UNITED STATES  
NUCLEAR REGULATORY COMMISSION  
OFFICE OF NUCLEAR REACTOR REGULATION  
WASHINGTON, D.C. 20555

December 30, 1988

**NRC BULLETIN NO. 88-07, SUPPLEMENT 1: POWER OSCILLATIONS IN BOILING WATER REACTORS (BWRs)**

**FIGURE 1  
DEFINED OPERATING REGIONS**

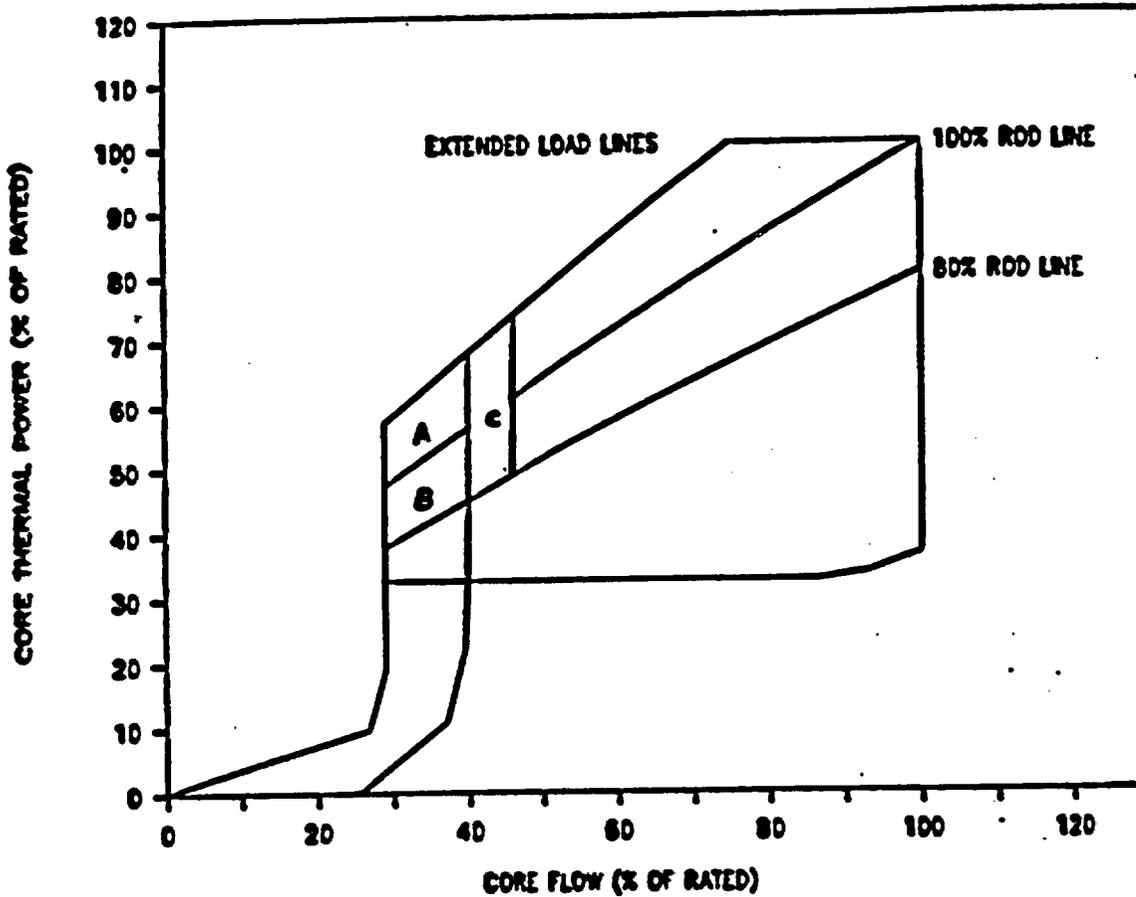
- (2) The boundaries of Regions A, B, and C shown in Figure 1 of the GE recommendations (Attachment 1) were derived for those BWRs using NRC approved GE fuel. For BWRs using fuel supplied by other vendors, these regions should be adopted in principle, but the power/flow boundaries should be based on existing boundaries that have been previously approved by the NRC. For proposed new fuel designs, the stability boundaries should be reevaluated and justified based on any applicable operating experience,

calculated changes in core decay ratio using NRC approved methodology, and/or core decay ratio measurements. There should be a high degree of assurance that instabilities will not occur under any circumstances of operation in Region C.

- (3) The BWROG recommendations of Attachment 1 are ambiguous with respect to permissible conditions for entry of Regions B and C. Although the recommendations state that intentional operation in Region B is not permitted and operation in Region C is permitted only for purposes of fuel conditioning during rod withdrawal startup operations, intentional entry into Region B or C is also allowable in situations where rod insertion or a flow increase is required by procedures to exit Regions A and B after unintentional entry. Licensees should ensure that the procedures and training employed for implementation of these recommendations avoid any similar ambiguity which could lead to operator confusion.

1. Intentional operation shall not be allowed in Region A or Region B of Figure 1.

2. If Region A is unintentionally entered:

Group 1 plant operators shall take immediate actions to exit the region. Immediate action consists of either:

Insertion of a predefined set of control rods which will most effectively reduce core thermal power.

Increasing recirculation pump speed if one or more pumps are in operation. Starting a recirculation pump to exit this region is NOT an appropriate action.

Group 2 plant operators shall manually scram the reactor to exit the region.

3. If Region B is unintentionally entered:

Group 1 and Group 2 plant operators shall take immediate action to exit the region. Immediate action consists of:

Insertion of a predefined set of control rods which will most effectively reduce core thermal power.

Increasing recirculation pump speed or recirculation flow (FCV plants) if one or more pumps are in operation. Starting a recirculation pump or shifting from low to high speed (FCV plants) to exit this region is NOT an appropriate action.

4. Intentional operation in Region C shall be allowed only for control rod withdrawals during startup requiring PCIOMR. This region should be avoided for control rod sequence exchanges, surveillance testing and reactor shutdowns.

5. If at any time during operation in Region A, B or C, core thermal hydraulic instability occurs, the plant operator shall manually scram the reactor.

Evidence of thermal hydraulic instability consists of APRM peak to peak oscillations of greater than 10% or periodic LPRM upscale or downscale alarms in addition to the guidance provided in SIL 380, Revision 1.
